Addendum 3 for RFB927940-04

Project Name: WRC Decentralization Phase 4 & Fire Alarm Phase 3 (9279.40 & 9279.41) Bid Issuance #4
DAS RFB #: 927940-04
DAS Project #: 9279.40 & 9279.41
Date: 6/2/2026

13-M402

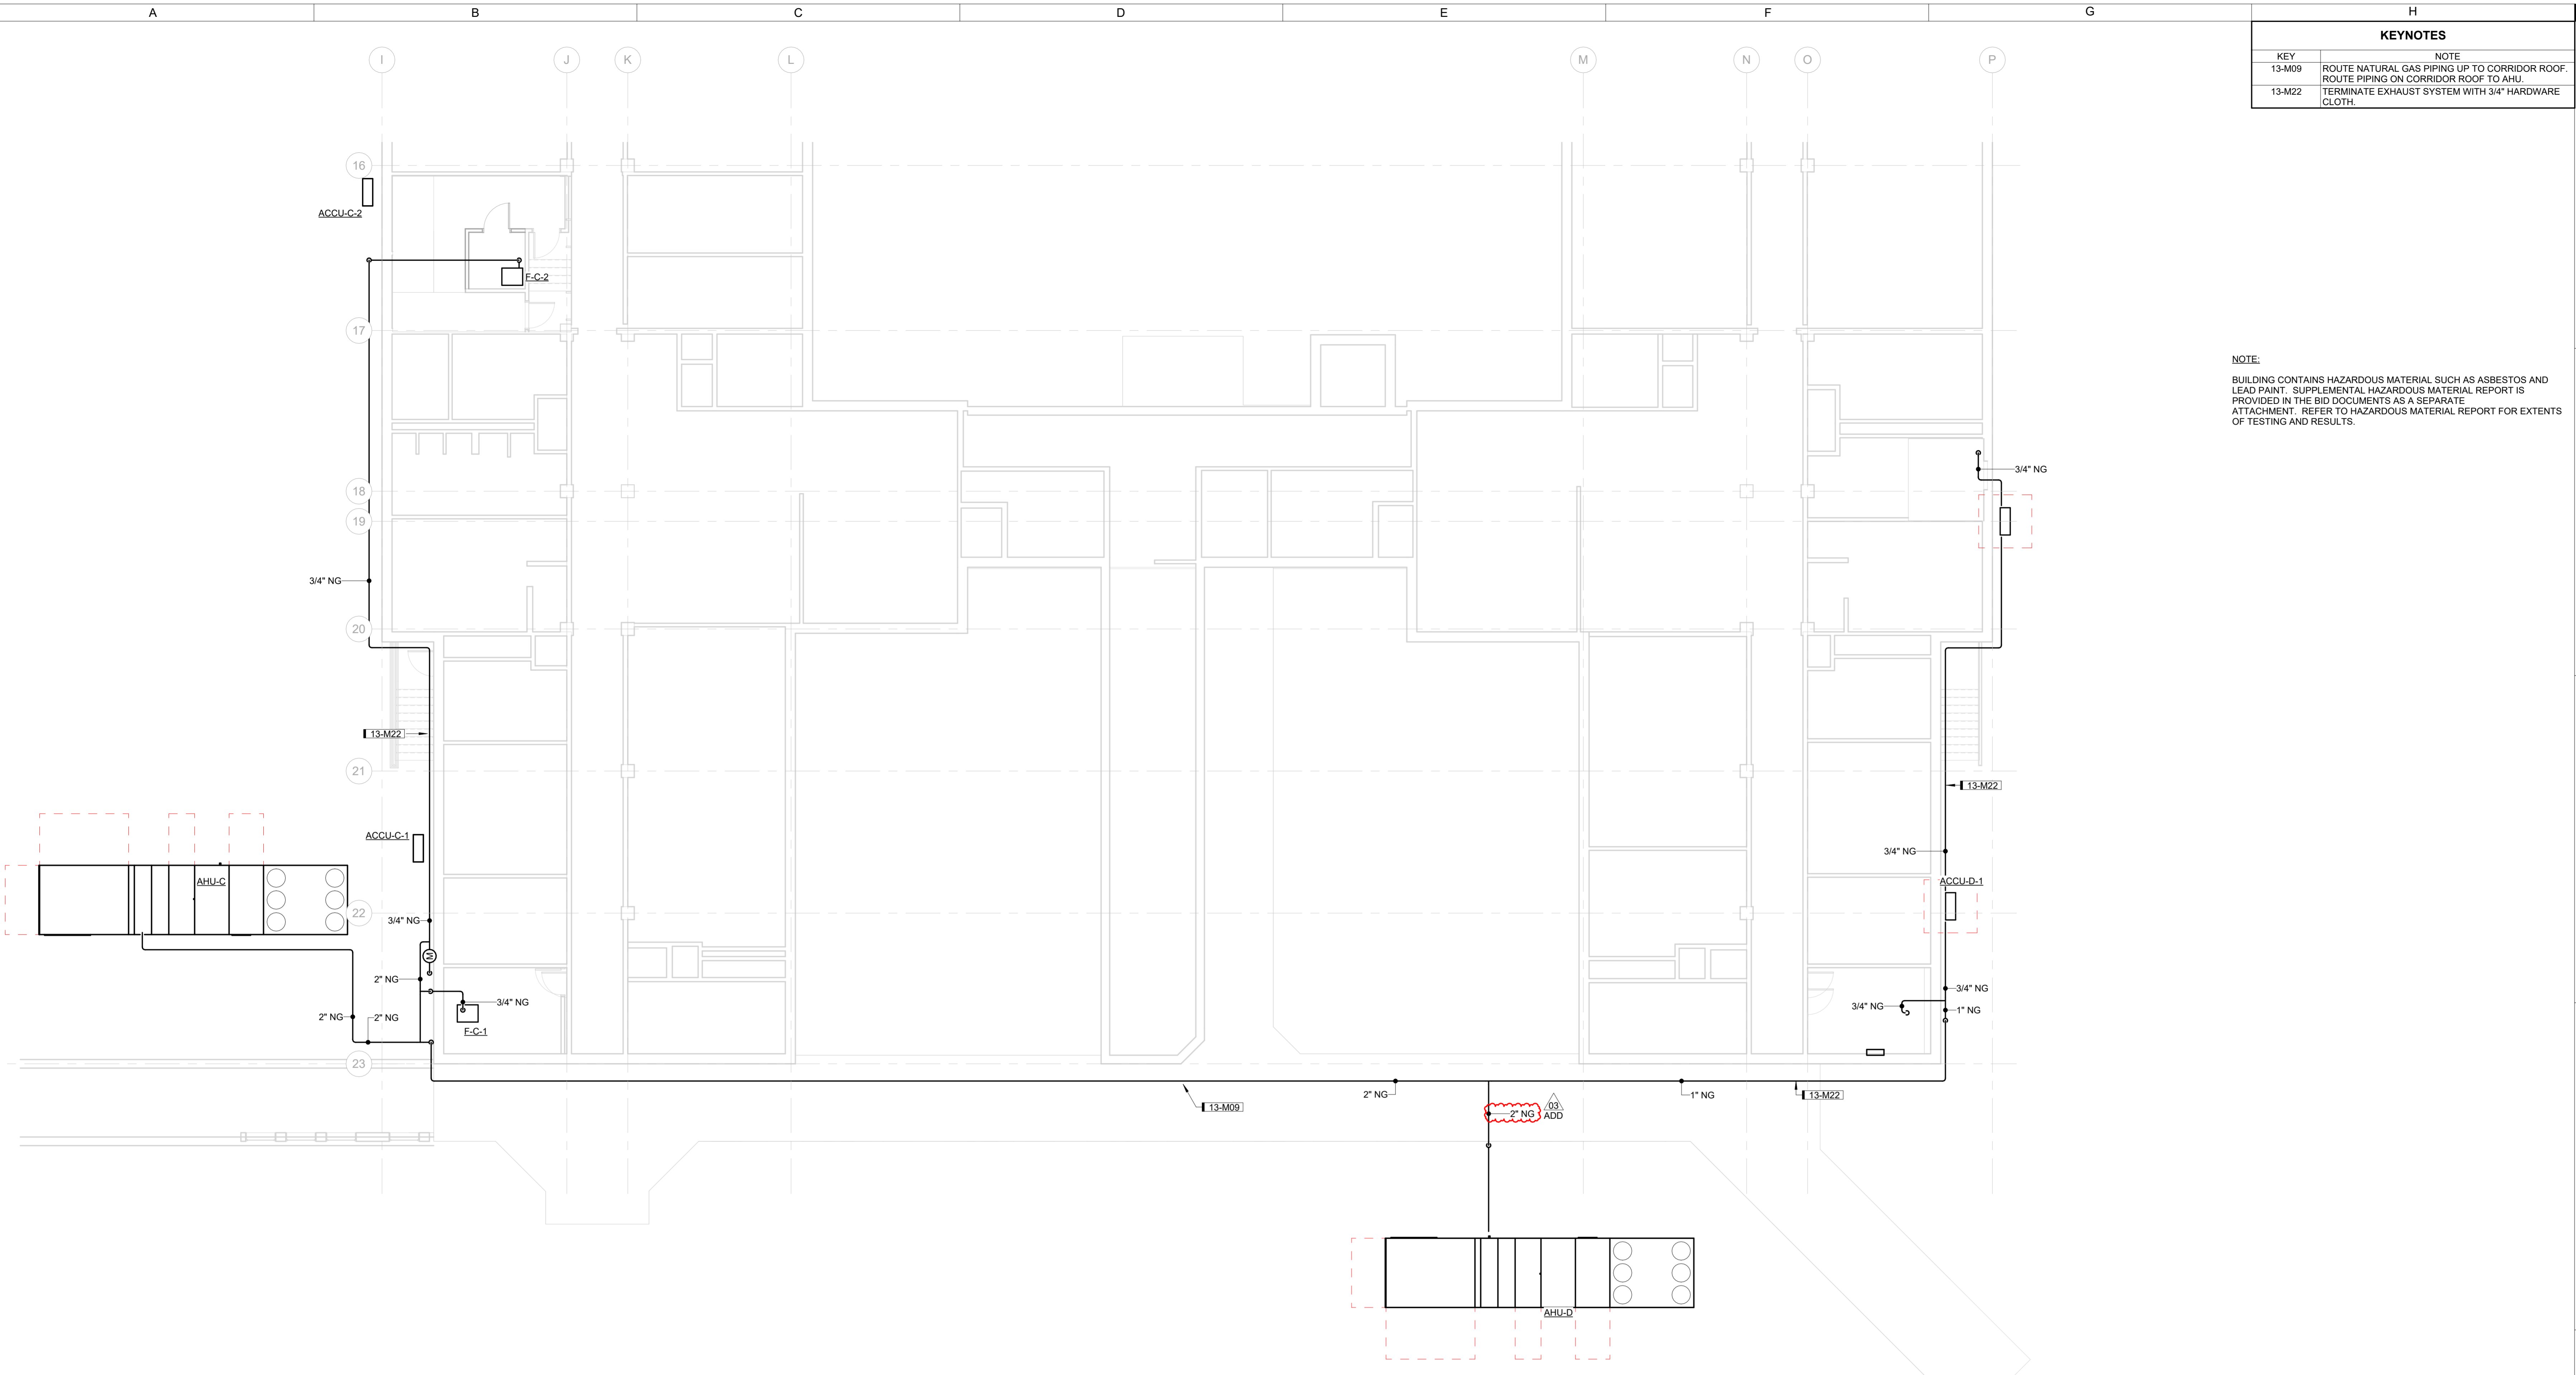
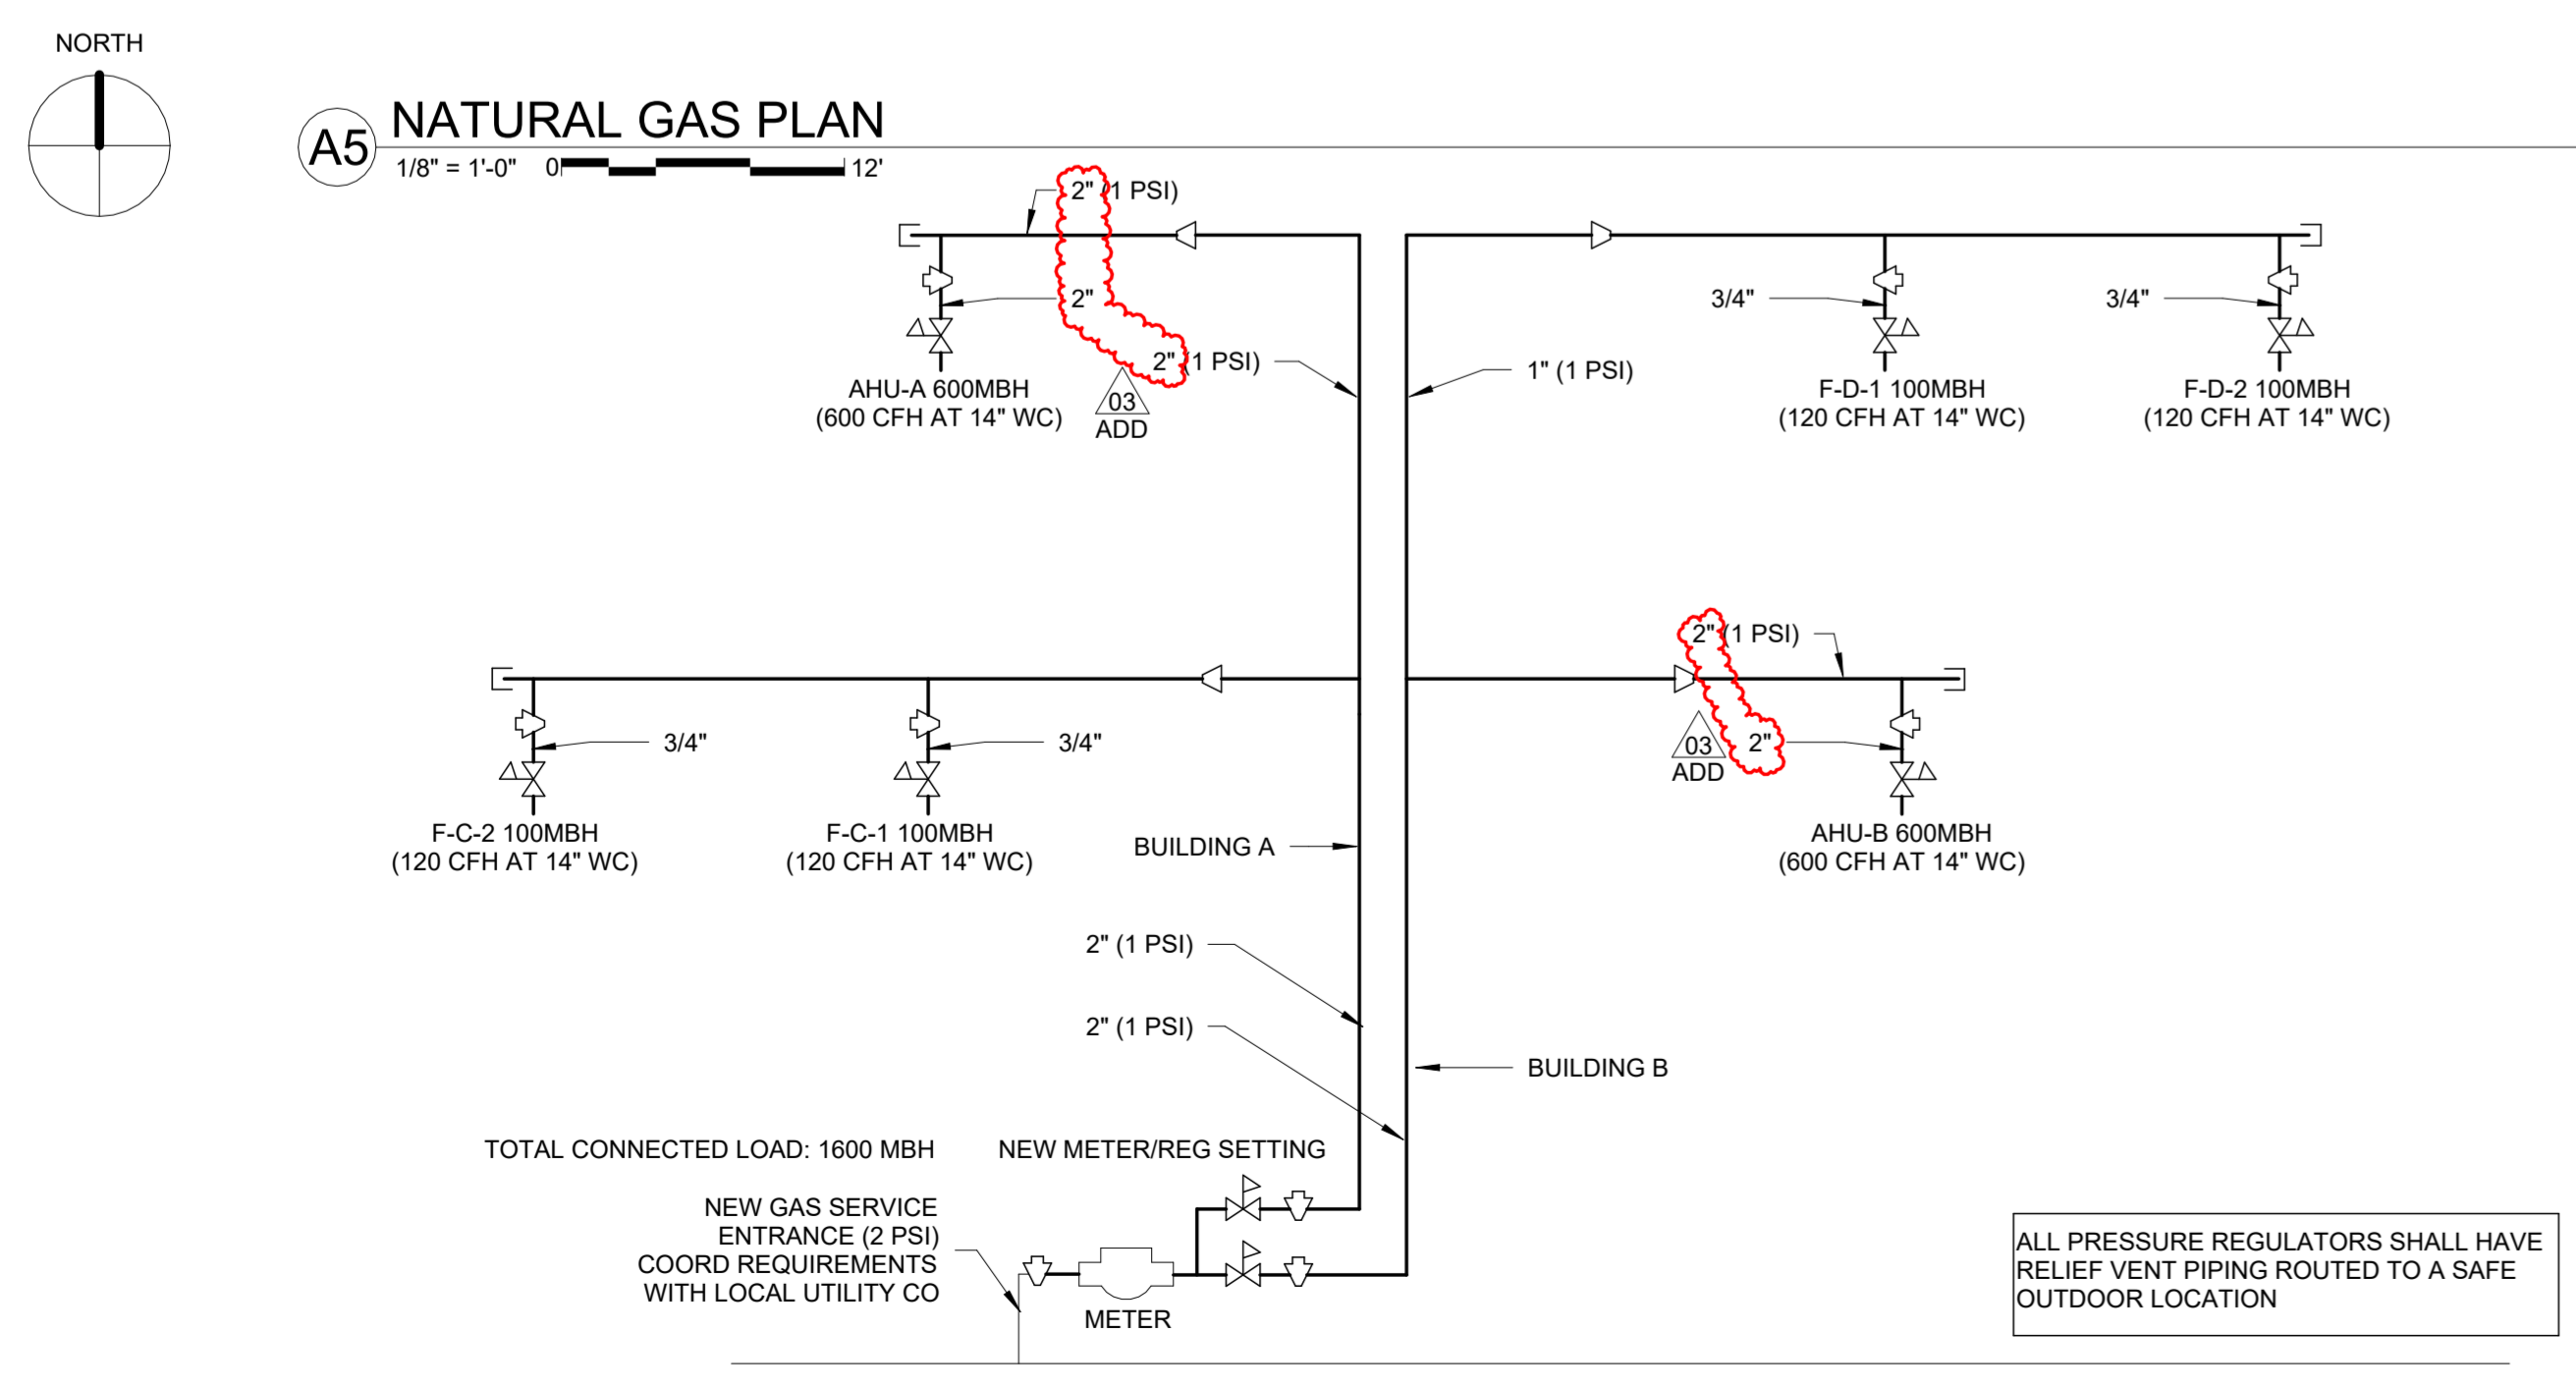
- **13-M402 – BUILDING C & C NATURAL GAS PLAN:**
 - **REVISE** Natural gas pipe sizing to AHU-C and AHU-D on Gas Piping Schematic.
- **13-M600 – MECHANICAL SCHEDULES:**

13-MD202

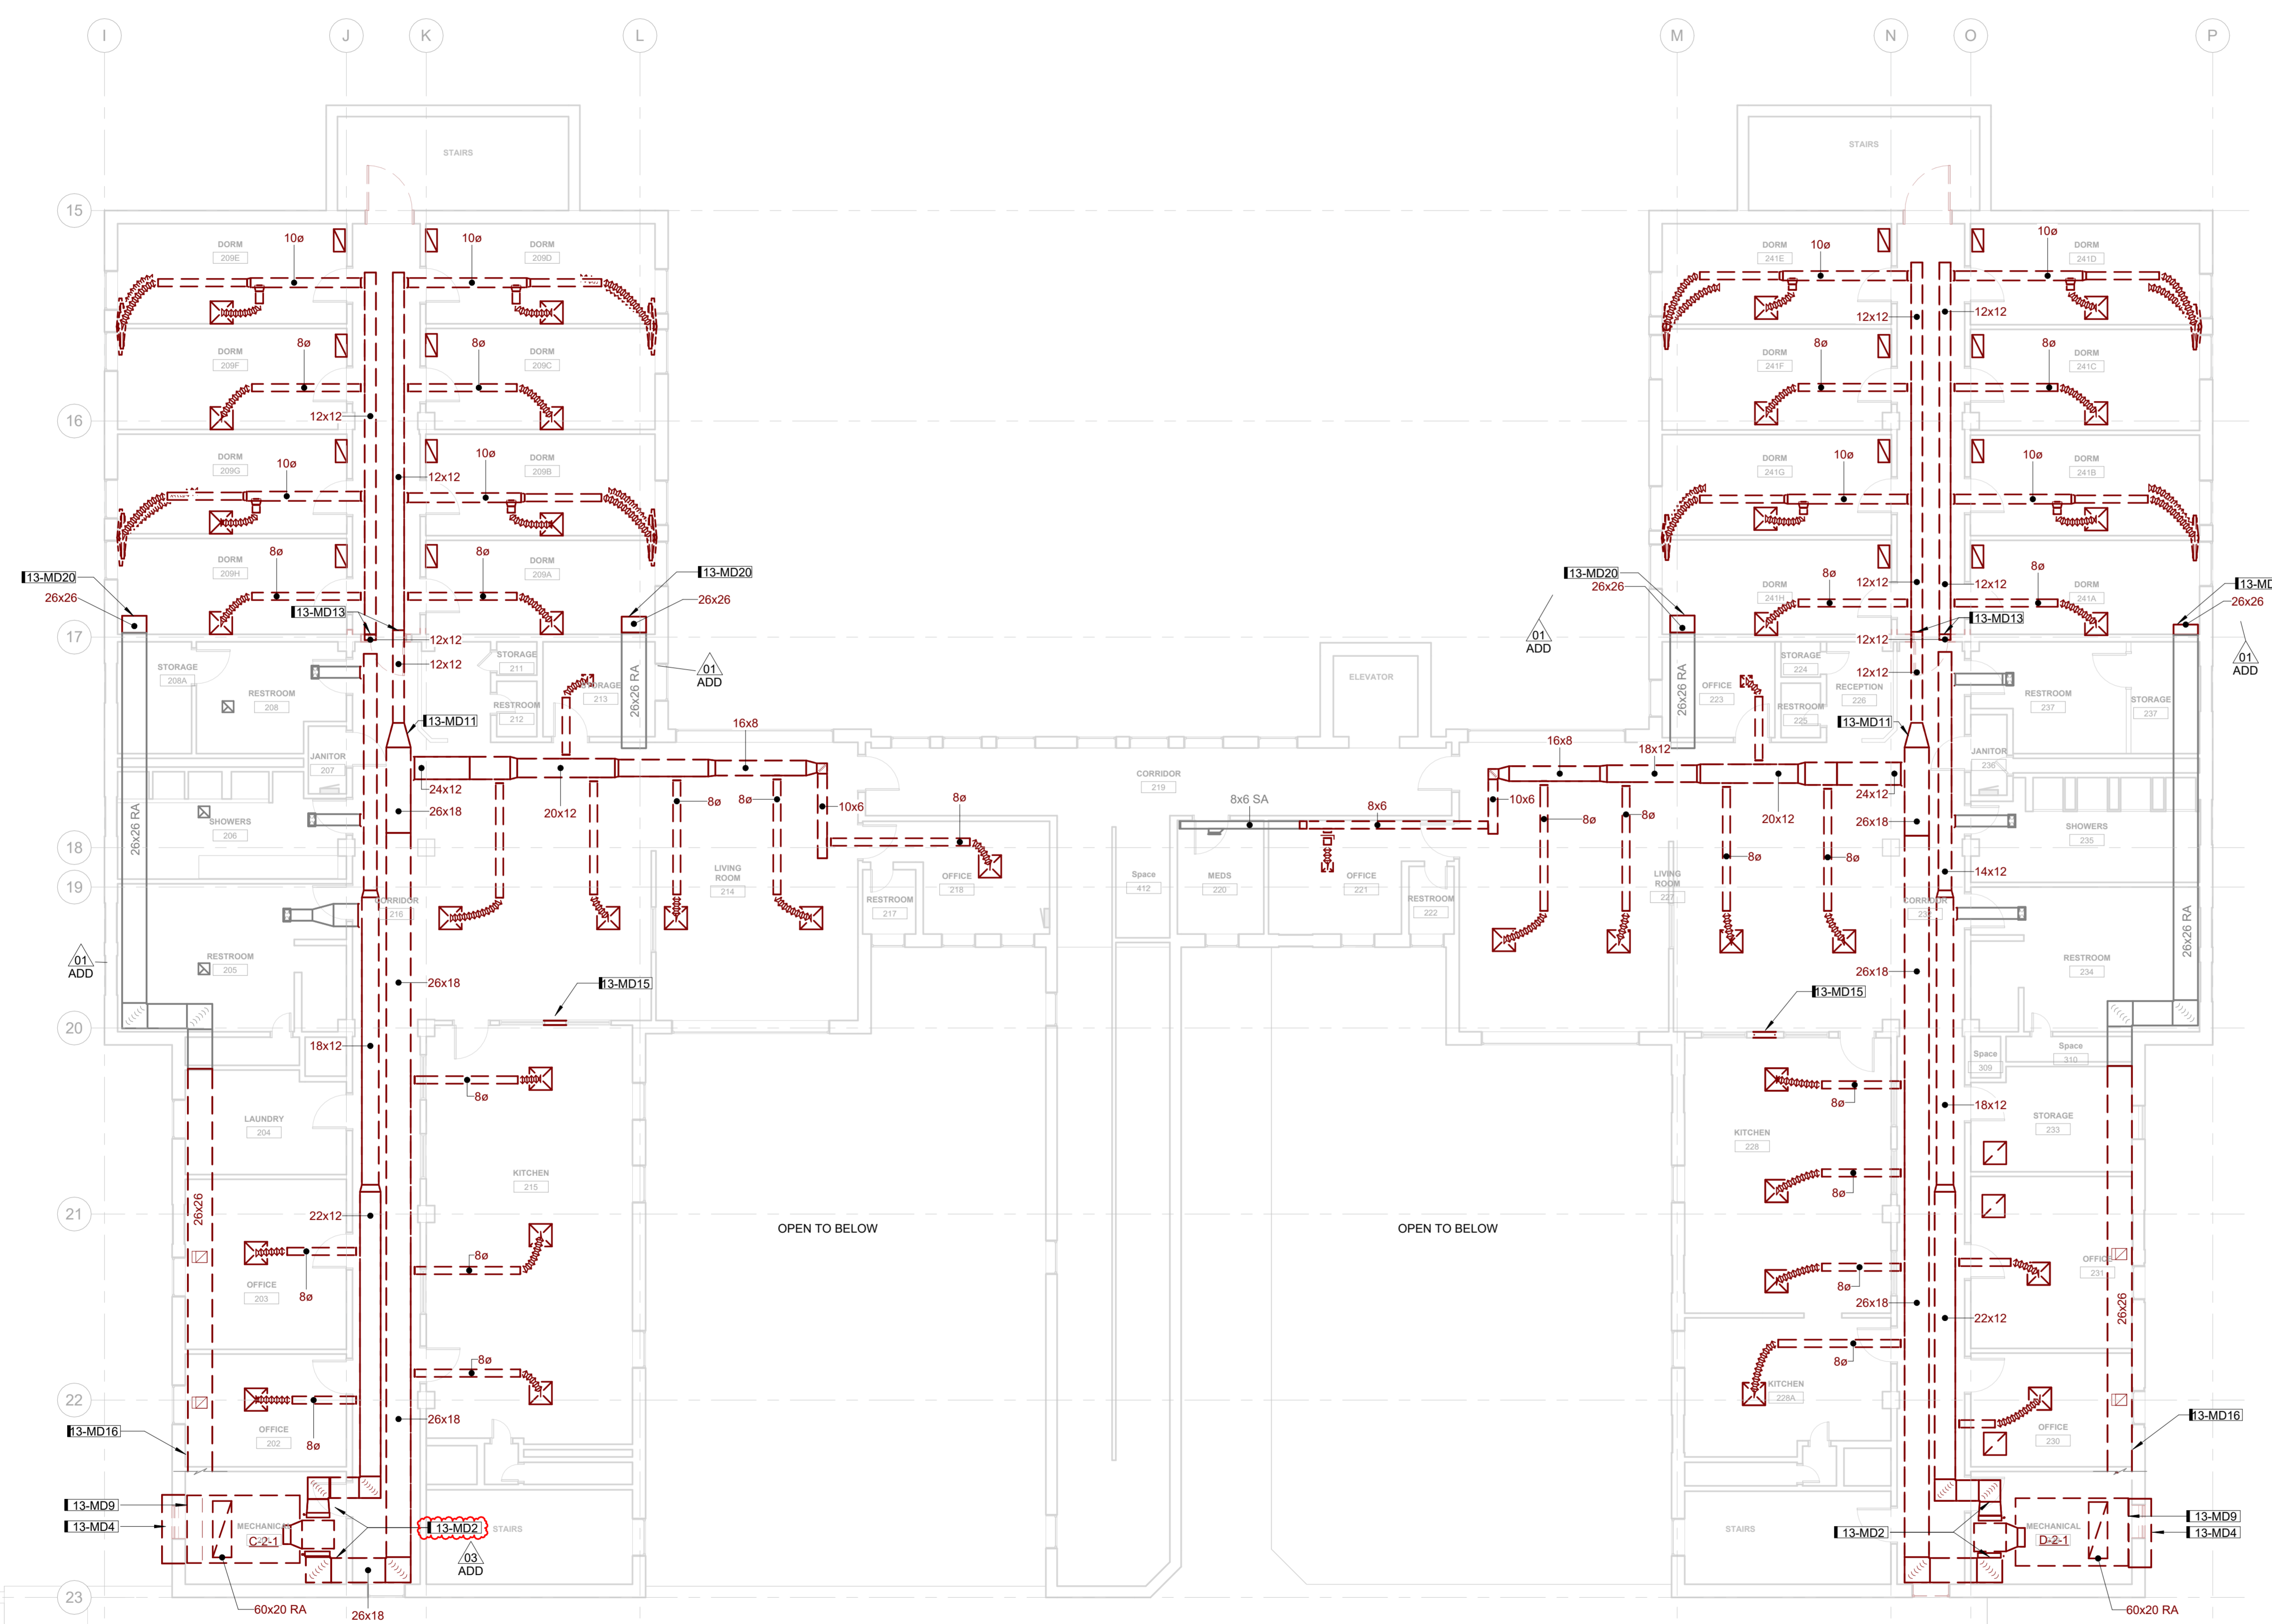
- **REVISE** Keynote pointing to heating coil I mechanical room to 13-MD2.
- **13-AD00 – BASEMENT DEMOLITION PLAN – BUILDING C & D**
 - **DELETE** window demolition shown on west side of Building C

KEYNOTES	
KEY	NOTE
13-MD2	DEMOLISH EXISTING DUCT HEATING COIL AND DUCTWORK INSIDE THE MECHANICAL ROOM.
13-MD4	DEMOLISH OA DUCTWORK BACK TO AHU. WALL PENETRATION TO BE REUSED FOR NEW OA DUCTWORK.
13-MD9	REMOVE EXISTING BLOWER COIL UNIT AND ASSOCIATED PIPING, OUTDOOR AIR DUCTWORK, AND CONTROLS. SUPPLY DUCTWORK TO REMAIN FOR RECONNECTION.
13-MD11	DEMOLISH EXISTING DUCTWORK AND ACCESSORIES IN THIS LOCATION. PREPARE DUCTWORK FOR NEW VAV AND DUCTWORK INSTALLATION.
13-MD13	REMOVE SECTION OF DUCTWORK FOR INSTALLATION OF NEW FIRE DAMPER. SEE NEW WORK PLANS.
13-MD15	REMOVE EXISTING KITCHEN TRANSFER DUCT AND GRILLE. INFILL AND PAINT WALL TO MATCH ADJACENT WALL COLOR.
13-MD16	DEMOLISH EXISTING RETURN DUCT TO APPROXIMATE EXTENT INDICATED. DESIGN INTENT IS TO DEMOLISH RETURN DUCTWORK WHERE CEILING REPLACEMENT AND ABATEMENT IS OCCURRING.
13-MD20	DEMOLISH PORTION OF EXISTING RETURN DUCT AS INDICATED BACK TO WALL AND PREPARE DUCT FOR NEW CONNECTION. VERIFY TERMINATION POINT AND NOTIFY ENGINEER IF TERMINATION POINT DIFFERS FROM ANTICIPATED LOCATION.
